MEMORANDUM

To: Historic District Commission
From: Jill Thacher, Historic Preservation Coordinator
Date: July 10, 2014
Re: Postponed Application for 416 East Huron Street

Staff Report

ADDRESS: 416 East Huron Street, Application Number HDC 14-085

NEW EAST ELEVATION

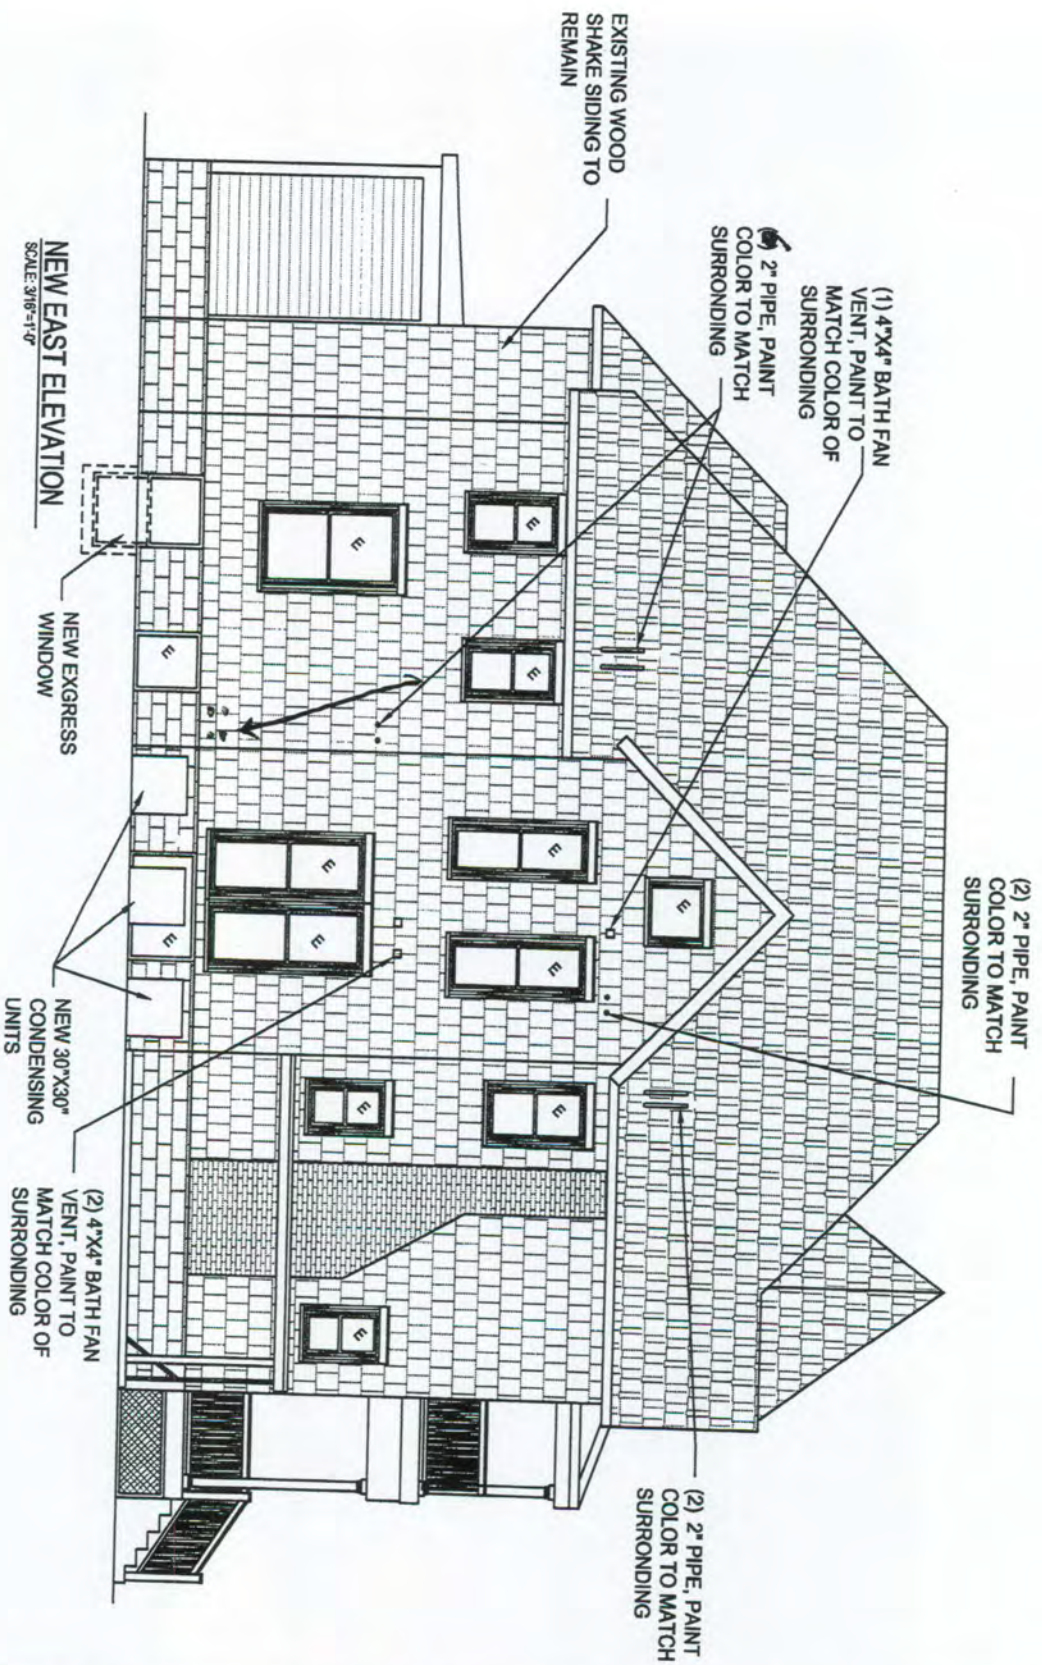
1. In this formerly single-family house, staff counted 18 bedrooms in six apartments on four levels on the drawings submitted for building permits and this HDC application. At its rental housing inspection in 2010, the house was certified for four efficiency apartments and one one-bedroom, with a total of six maximum occupants in the structure.
2. The owner is requesting to install three new air conditioning condensers along the east side of the building; four 2" pvc pipes extending out of the roof near the east eave; eight 2" pvc pipes extending out of the east elevation of the building; five 4"x4" bath fan vents (three on the east elevation and two on the west); four 30"x58" skylights; and one

3. The egress window would be located near the back of the building and the width would match the width of the existing opening. One other egress window was previously approved by the Commission at the rear of the west elevation. The drawings supplied are contradictory and staff has requested revised drawings to clarify the size and well materials. If this egress window matches the one previously approved, it is an appropriate location for an egress window since it is near the rear of the house and probably not visible from the public right of way. If approved by the Commission, it is staff's opinion that no additional basement egress windows should be approved in the future unless they are on the rear elevation of the building.

Pairs of PVC pipes extending out the side wall of the house and multiple other vents are not compatible with the historic materials, features, size, scale, and proportions of this historic Queen Anne house.

9. The work also does not meet the *City of Ann Arbor Historic District Design Guidelines* for Mechanical Equipment. The vents in particular detract from the historic integrity of the house.
10. In order to correct the application, staff suggests reducing the number of vents and condensers required, and reconfiguring vents to go through non-character-defining portions of the roof and rear elevation.

NEW SOUTH ELEVATION
SCALE: 3/16"=1'-0"

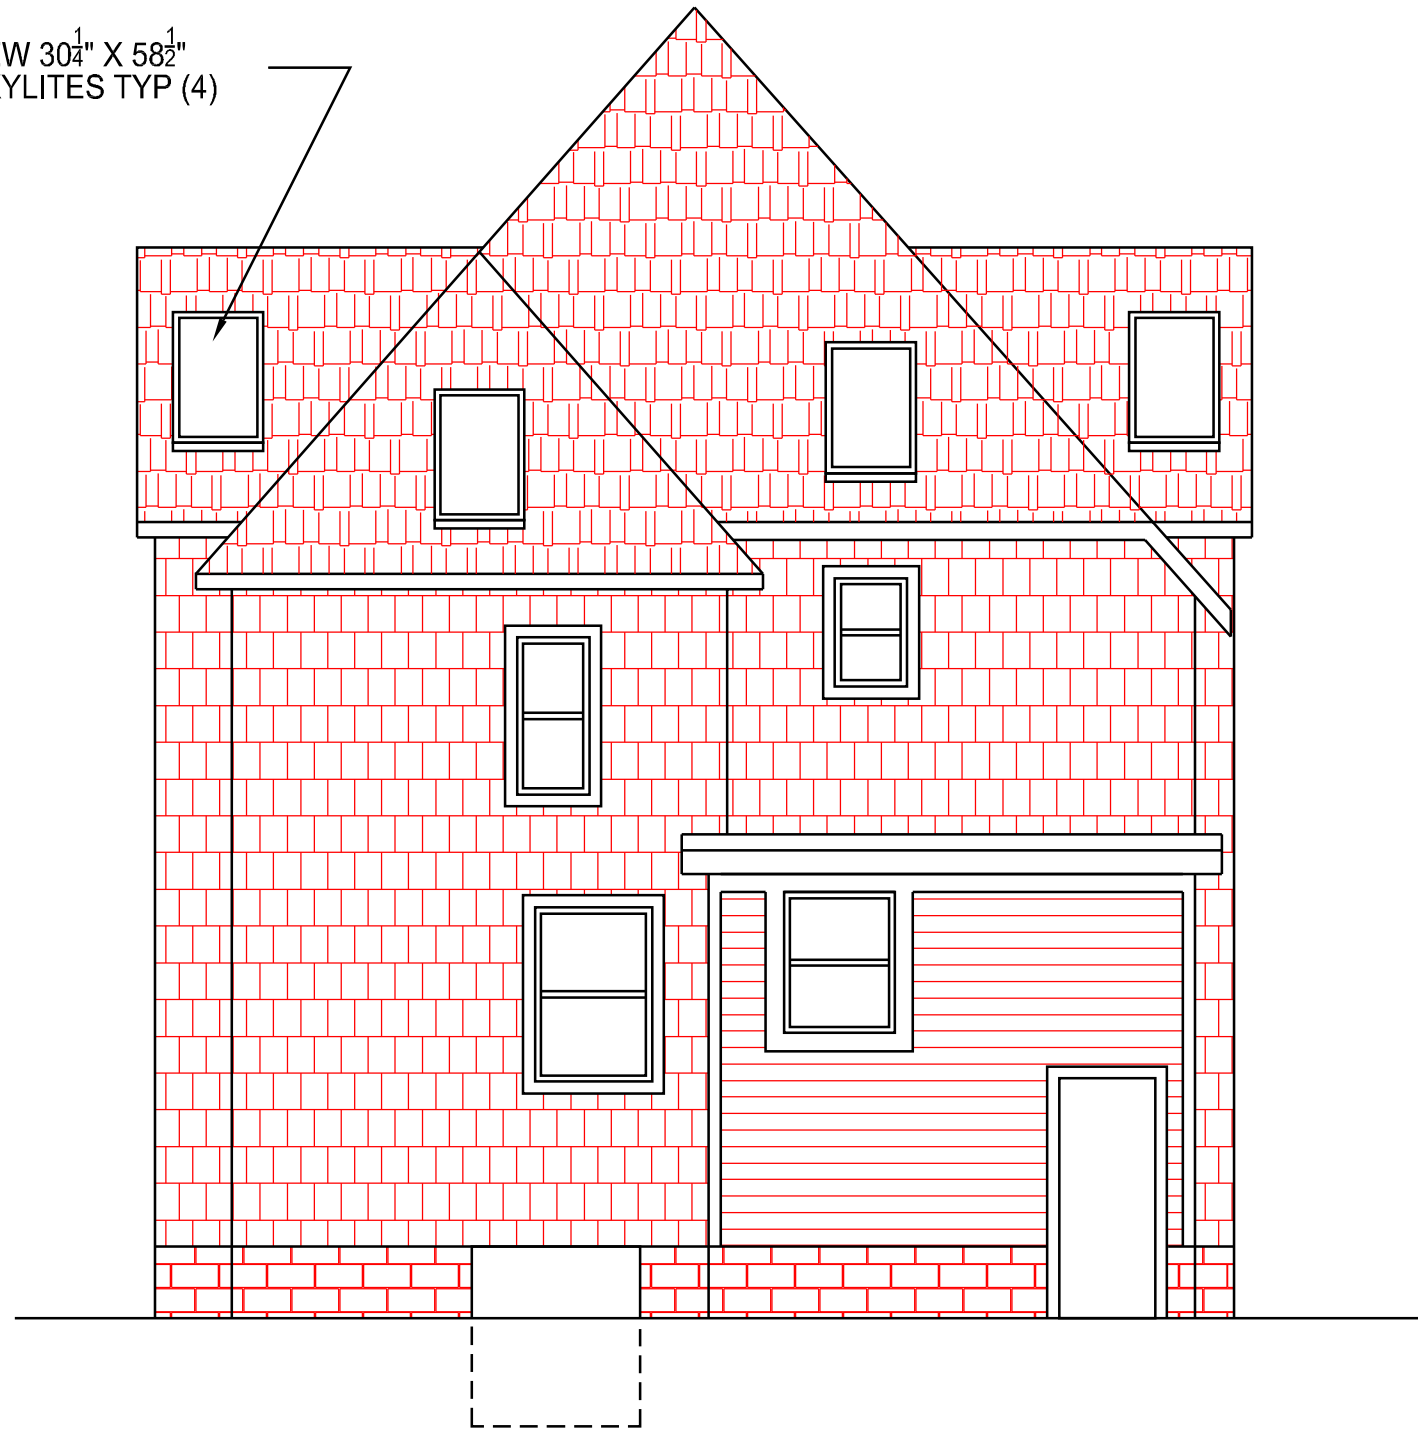
4. The skylights would be located on rear-facing roof surfaces, two on the side-gabled bumpouts and two on rear roof surfaces. They are required for egress since the attic is being converted to five bedrooms. One skylight already exists near the front of the house facing the street.
